Groundwater Transfer Review Summary Form

Transfer/PA # T- 14766

Ground Water Review Form:

Applicant Name: Threemile Canyon Farms

Figure 1. Map of well locations.

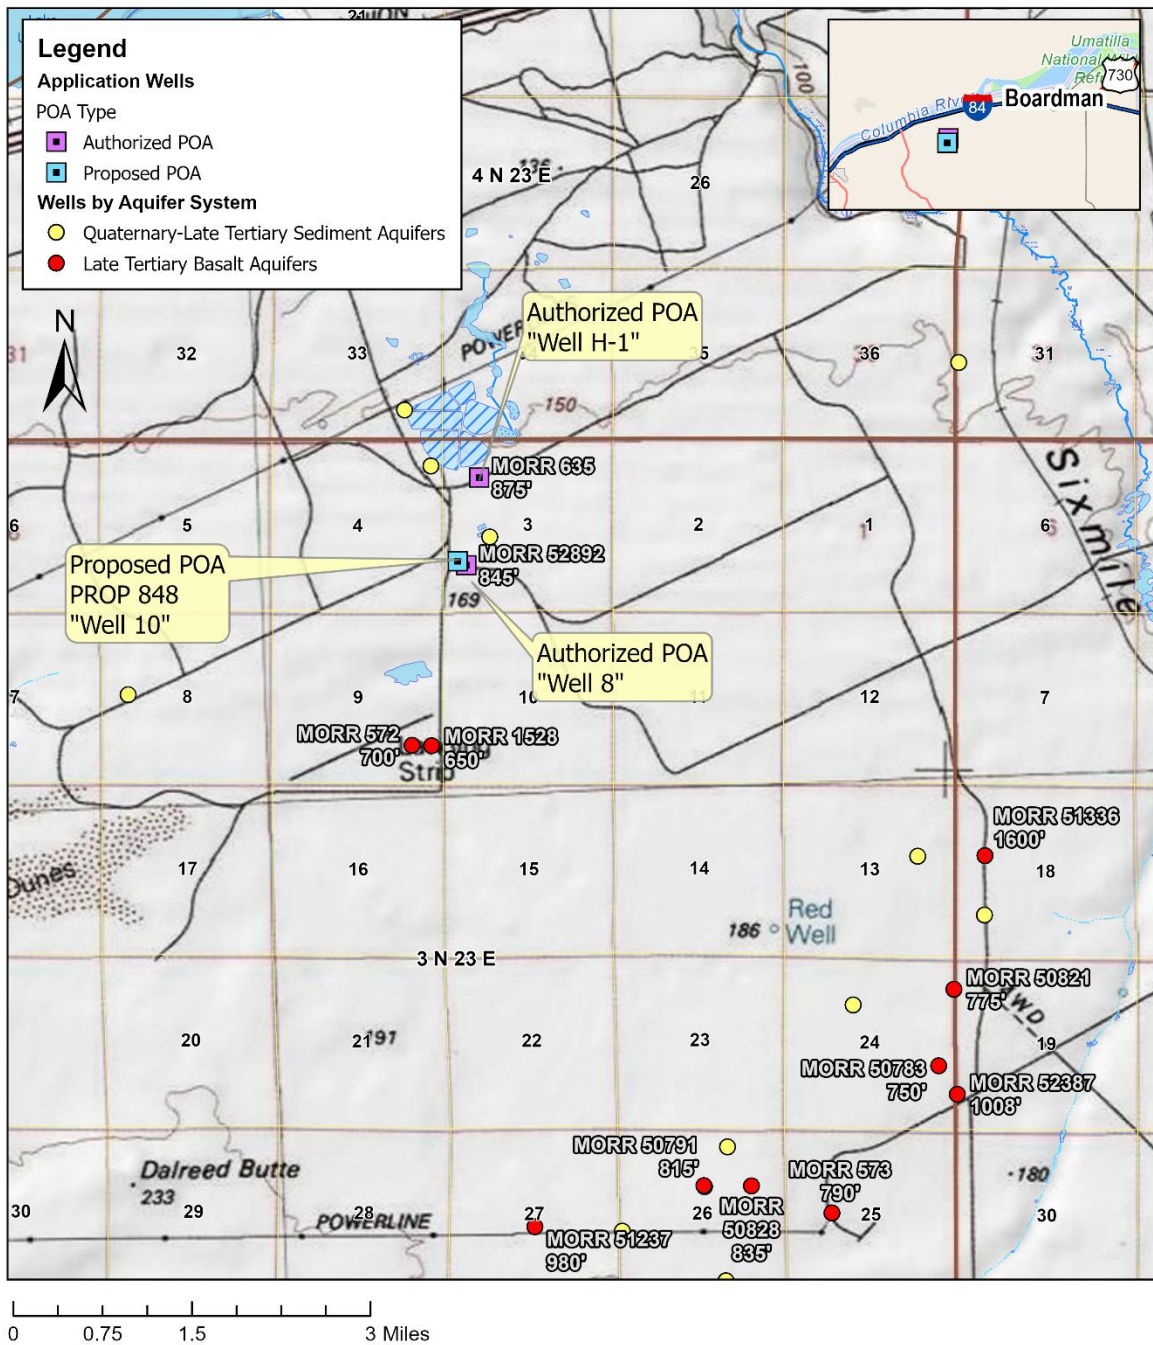
5. a) Will this proposed change, at its maximum allowed rate of use, likely result in an increase in interference with **another ground water right**?
☐ Yes ☒ No Comments: PROP 848 (Well 10), the proposed APOA would be farther away from the nearest wells that access the same basalt aquifer. The APOA, PROP 848, is approximately 3.9 miles away from MORR 50821. The approved POA, MORR 52892, is approximately 3.8 miles away from the closest POA. The change will decrease interference.

Figure 2. Hydrograph of groundwater-level elevations from select wells representing the basalt aquifer accessed by the authorized POAs.

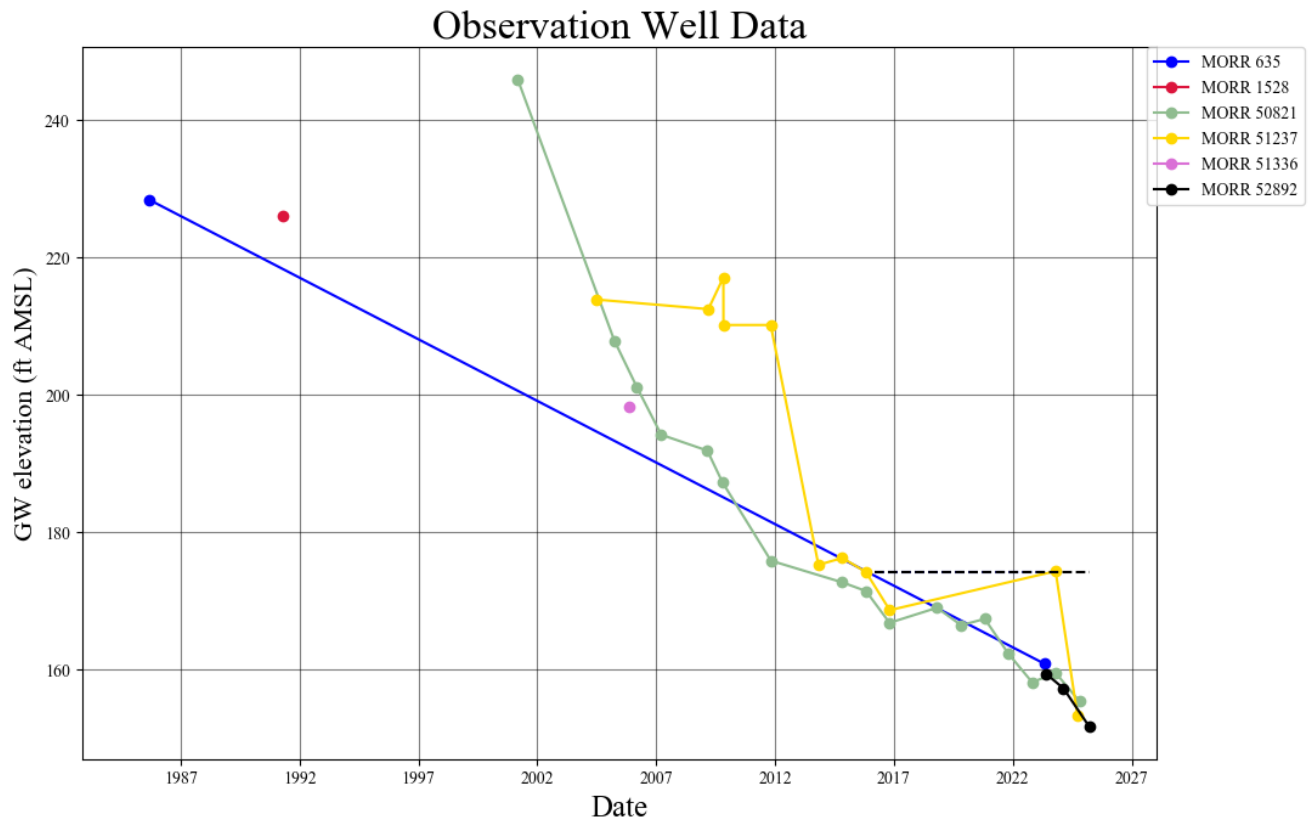
b) If yes, for each POA identify the reference level, most recent spring-high water level, and whether an applicable permit decline condition has been exceeded: MORR 635 (Well H-1) has a reference level of 336.07 feet bls based on the estimated groundwater level on 03/01/2016. This estimate was calculated from the groundwater-level trend observed between when the well was constructed (281 feet bls [228.4 feet amsl]) and the first static water level measurement taken on 05/01/2023 (348.50 feet bls [160.90 feet amsl]).

MORR 52892 (Well 8) has a reference level of 368.67 feet bls based on the estimated groundwater level on 03/01/2016. Although MORR 52892 was not constructed until 05/31/2023, this estimate represents the water level in the target aquifer, which was calculated based on the groundwater-level trend observed in MORR 635. The most recent static water level measurement was 390.25 feet bls (151.75 feet amsl) on 03/20/2025.

Neither well has exceeded applicable permit decline conditions. Static water level measurements are not available for MORR 635. Instead, the 2.40 ft/yr declining water level trend at MORR 52892 from 2016 to 2025 is assumed to represent the water level in the target aquifer at both wells. As of March 2026, the water level in MORR 52892 is estimated to have declined 23.97 feet, from the 2016 reference level of 368.67 feet bls to 393.67 feet bls.

8. What conditions or other changes in the application are necessary to address any potential issues identified above: none
9. Any additional comments: If the groundwater level trend observed since 2016 continues at the current rate or accelerates, it is likely that the permit decline condition will be exceeded in 2027. It should also be noted that the proposed APOA will have a reference level based on the estimated water level elevation in 2016, similar to MORR 635 and MORR 52892.
